**A RESOLUTION APPROVING A CONDITIONAL USE PERMIT PROJECT 403 W.  
WEAVER STREET ALLOWING FOR EXPANSION OF USES WITHIN THE  
EXISTING BUILDING  
Resolution No. 38/2011-12**

**STAFF REPORT**

**PROJECT:** 403 W. Weaver Street CUP

**PURPOSE:** Requesting a Conditional Use Permit for 403 W. Weaver Street allowing additional permitted uses and authorizing future building expansion areas.

**Site Plan - 1"= 20'**

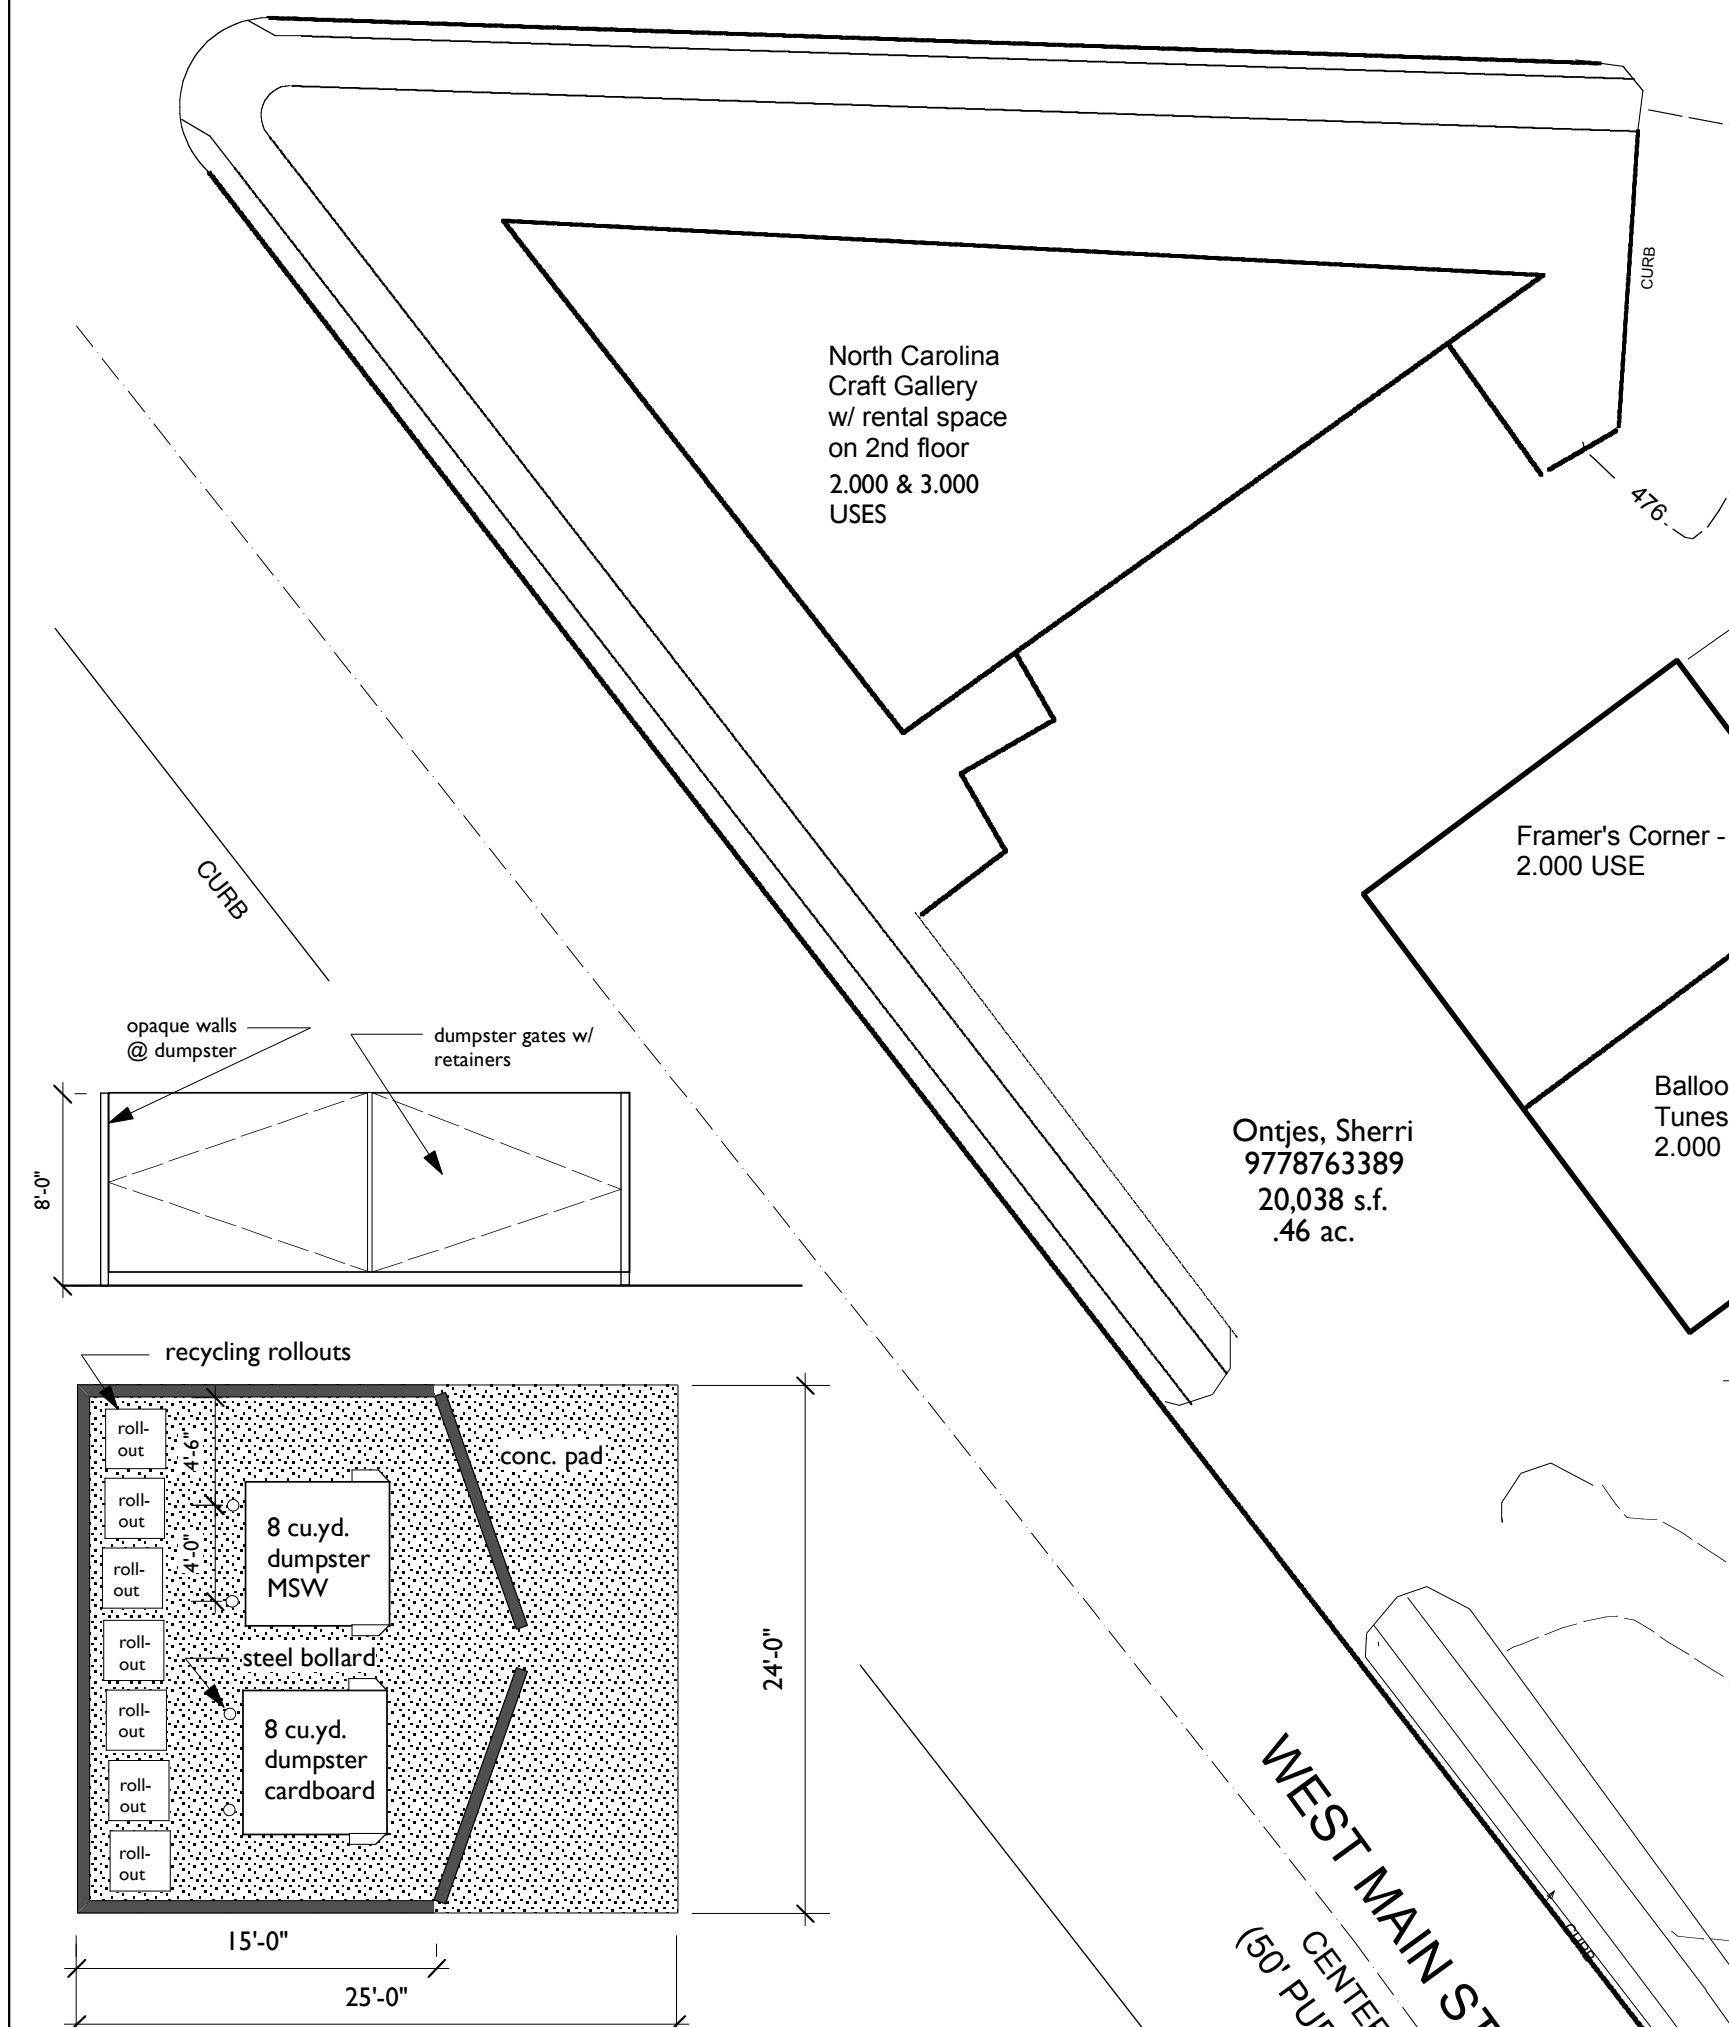
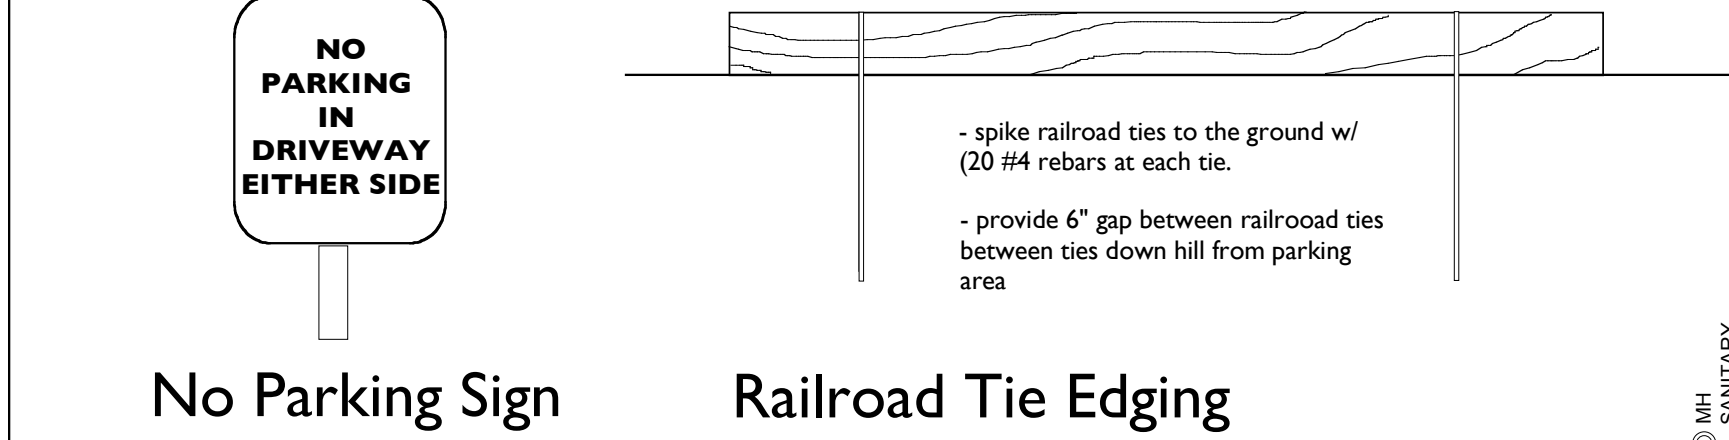
Because only six spaces are provided on the site, the applicant is not required to pave the lot. In addition, the B-2 Zoning District definition requires, to the extent practicable, that parking be located behind the building. The existing site layout features two parking spaces in the front northeast corner of the property. The applicant believes these spaces should be allowed to remain due to the limitations of the site and their relatively minor impact to the surrounding area (read justification on Attachment E). If the Board agrees with this assessment the following condition is recommended.

Section 15-221(f) of the LUO requires a 10' sidewalk be provided in the B-2 zoning district. This requirement would be applicable to the property frontage along Weaver Street. The existing sidewalk is 5'. The owners find this requirement unreasonable and have provided a written justification explaining their reasons (Attachment E). Section 15-126(c-2) grants the Board permission to allow the non-conformity of the existing sidewalk to remain provided that the applicant provides reasonable justification. If the Board finds the justification acceptable the following condition is recommended.

The presumptive screening requirements of Section 15-308 of the LUO requires a Type B screen to the west (satisfied by existing vegetation), a Type C screen to the north (satisfied by existing vegetation), no screen to the south and a Type B screen to the east. Along the eastern property line, due to the shared driveway the applicant has provided written justification that this standard cannot be reasonably satisfied (Attachment E).

For the restaurant use, a dumpster and accessory roll out containers will be necessary. The plans show a potential dumpster pad location acceptable to all the property owners so impacted. This location is also acceptable to Orange County Solid Waste though the Town's Solid Waste department would like to further review the arrangement at the time such a use is pursued. Because of this, the plan includes a note activating this re-review in the event that a restaurant is pursued.

- That bike parking be increased to a minimum of 10 spaces
- That nothing be done to the site to preclude the sidewalk from being widened to 10 ft. in the future

- That, due to the justification provided by the applicant regarding the site's limitations, the two parking spaces located in front of the building along Weaver Street be allowed to remain even though the property is located in the B-2 district which strives to locate parking areas behind buildings so they are not readily visible from the street.

- That the 10' sidewalk width requirement of section 15-221(f) be waived based on the applicant's justification that the non-conformity of the existing sidewalk should be allowed to remain.

- That, per the provisions of Section 15-309 of the Carrboro Land Use Ordinance, the screening requirements of Section 15-308 as they are applied to eastern property line are waived based upon the applicant's screening justification letter.
